FST2XT Software Change History

Issued by: NEW Lift Steuerungsbau GmbH

Release: FST V0157, 16.06.2020

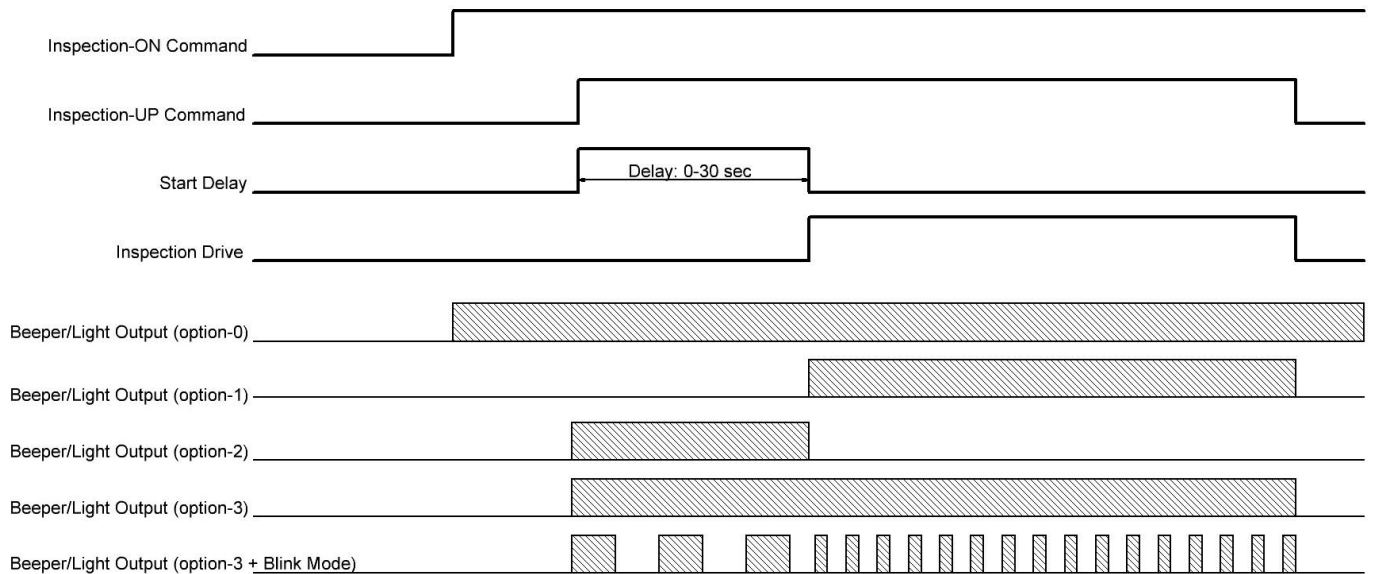
2) Inspection end-switch Monitoring: New function added for Shaft-Top or Bottom switches. The function is set to operate by using one or two of the new input I/O Port:

Menu: Port RAW = 0000 0000 0000 000T 0100 0010 1111 001x

T=0 tests input for activation in Bottom floor

T=1 tests input for activation in Top floor
